STAFF REPORT

PLANNED RESIDENTIAL COMMUNITY PRC 86-C-023-02

APPLICANT: Chick-fil-A, Inc.
ZONING: PRC, Planned Residential Community
PARCEL: 11-4 ((12)) 1B pt.
SITE AREA: 33,505 square feet
PLAN MAP: Residential Planned Community
PROPOSAL: To permit a fast food restaurant

COVER SHEET
 RESTON SECTION 57, BLOCK 1
 NORTH POINT VILLAGE CENTER
 CHICK-FIL-A
 HUNTER MILL DISTRICT
 FAIRFAX COUNTY, VIRGINIA

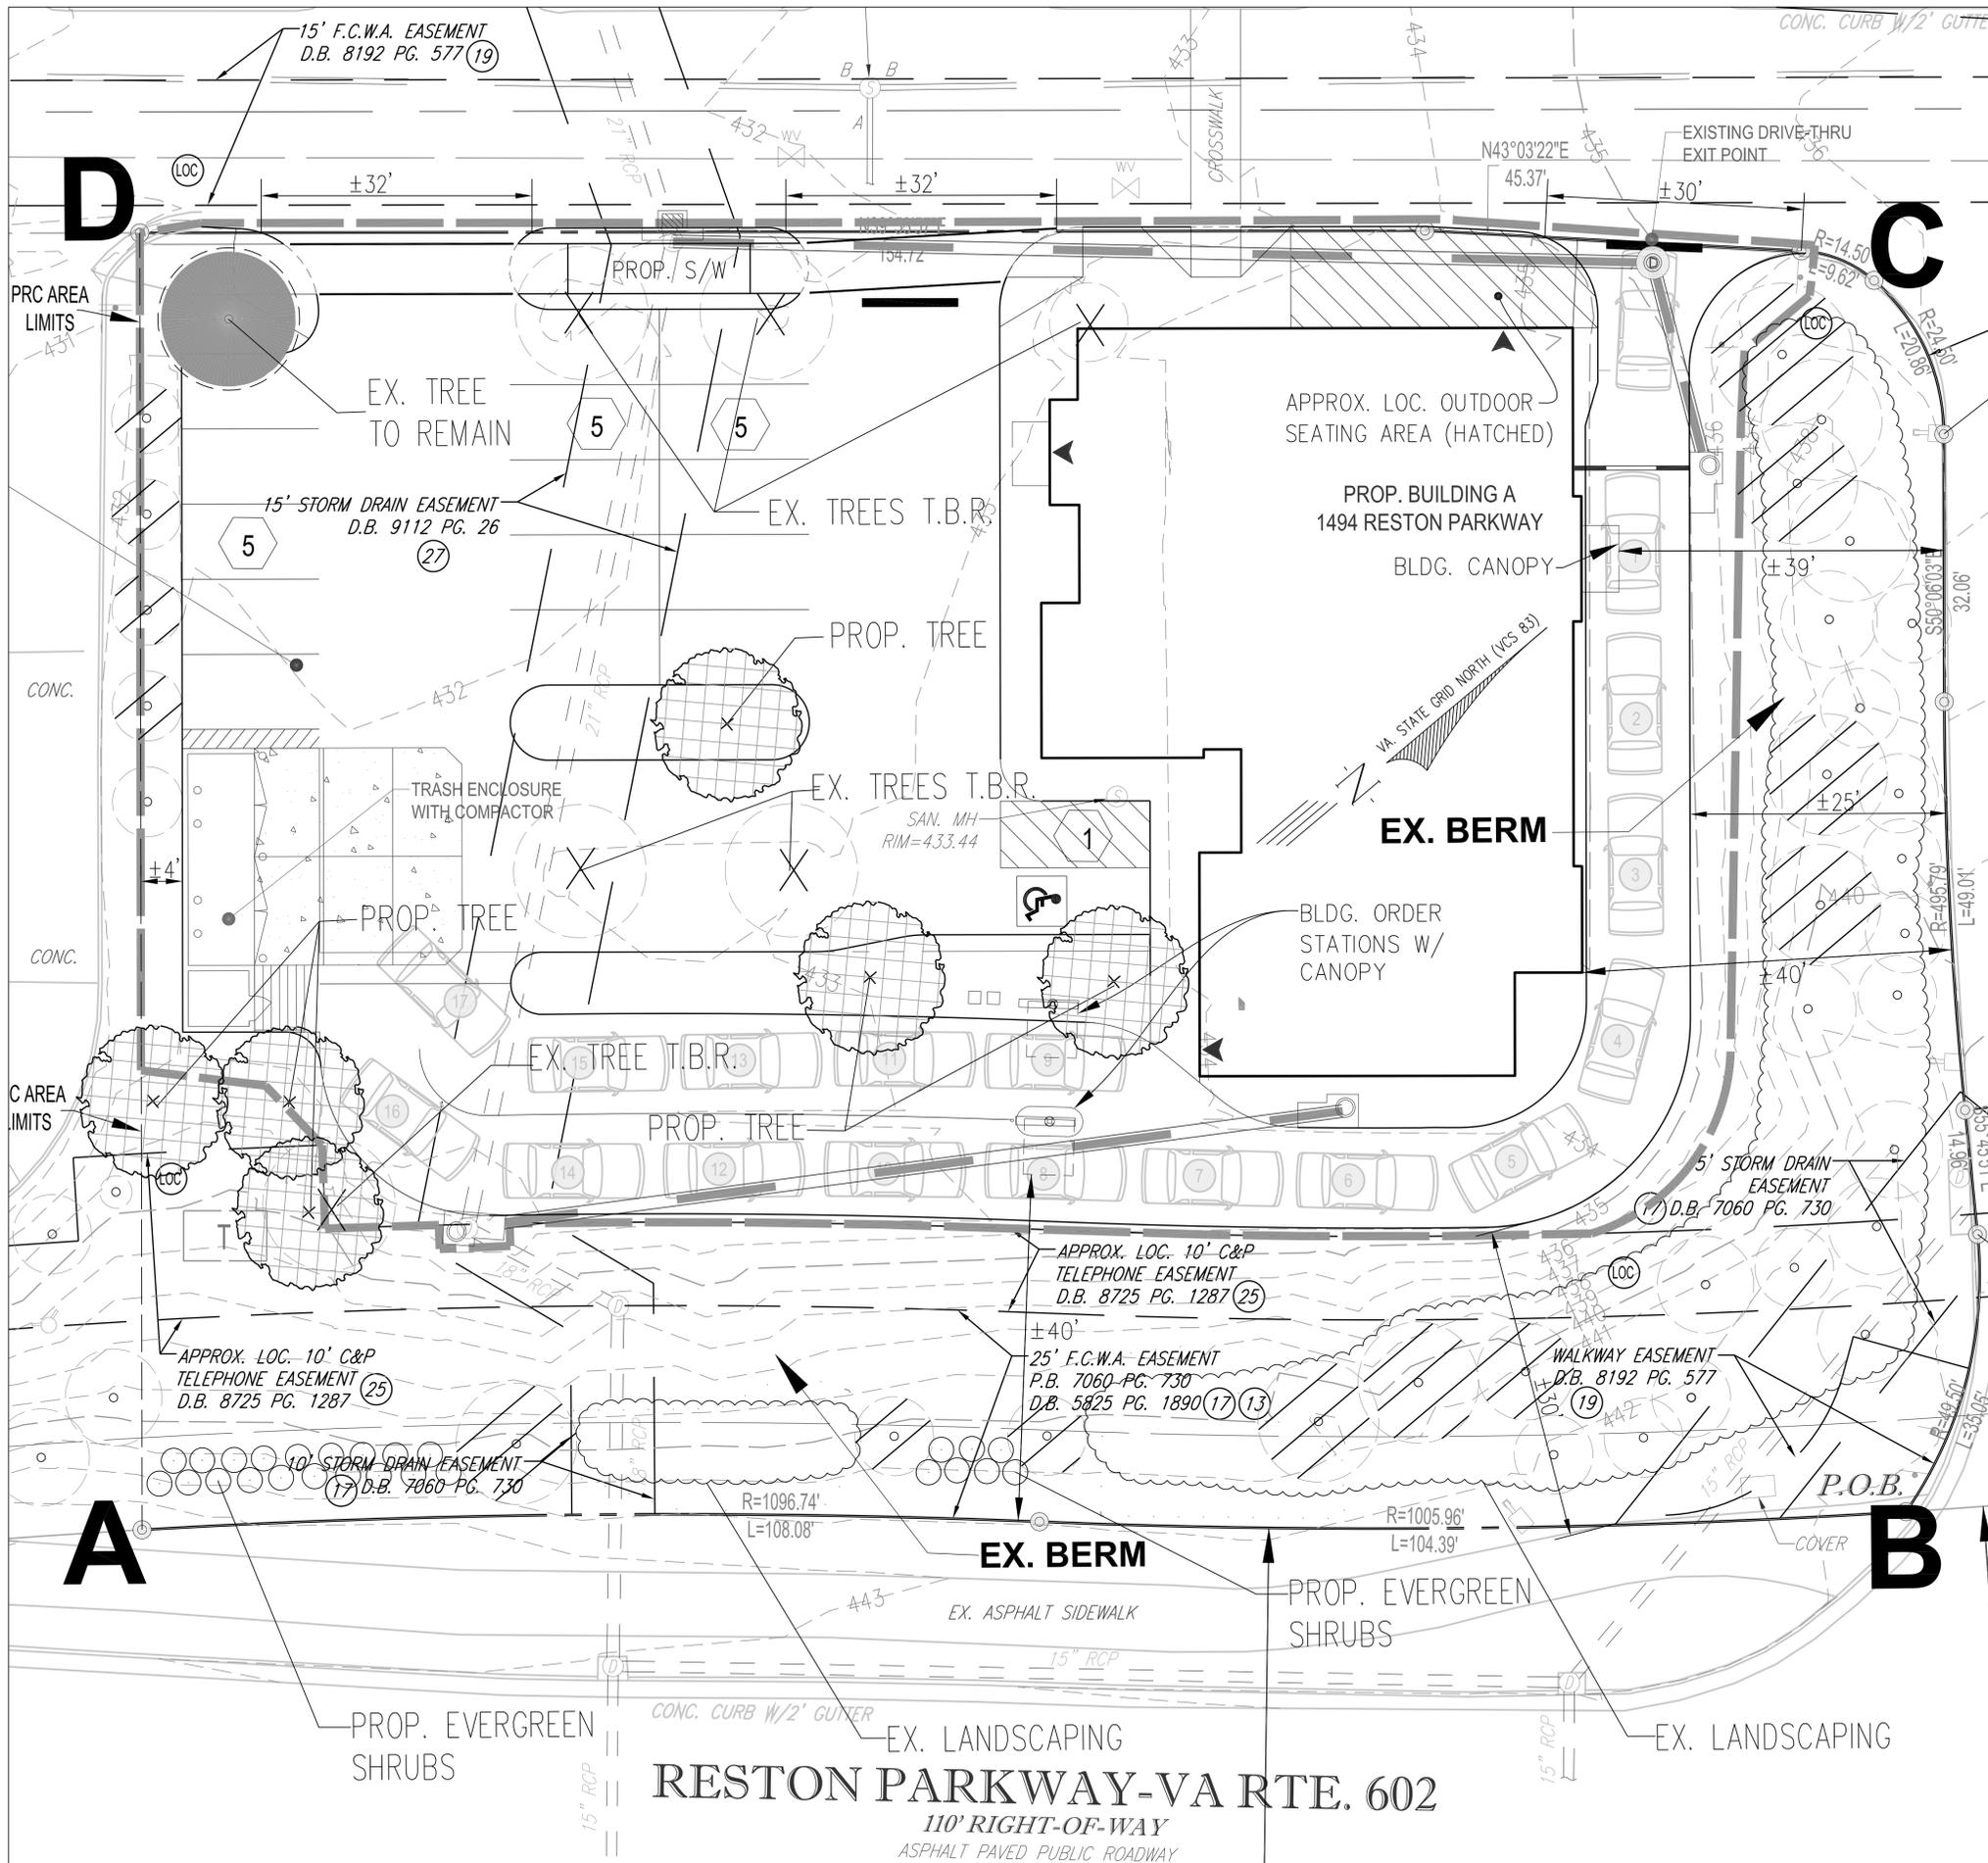
The Urban Forest Management Division (UFMD) and the applicant concluded that 1/40 linear feet shown on Sheet 12 of the development plan is the correct measurement used for calculating the required trees along the A-B property line, located along Reston Parkway. In addition, the peripheral parking lot landscaping chart on Sheet 12 has been updated to include a column for the provided peripheral parking lot landscaping width. All issues have been addressed.

1. **Comment:** The peripheral parking lot landscaping defined on sheet 12 of 13 incorrectly lists required trees calculation as 1/40 l.f. for A-B property line however is adjacent to the Reston Parkway right of way.
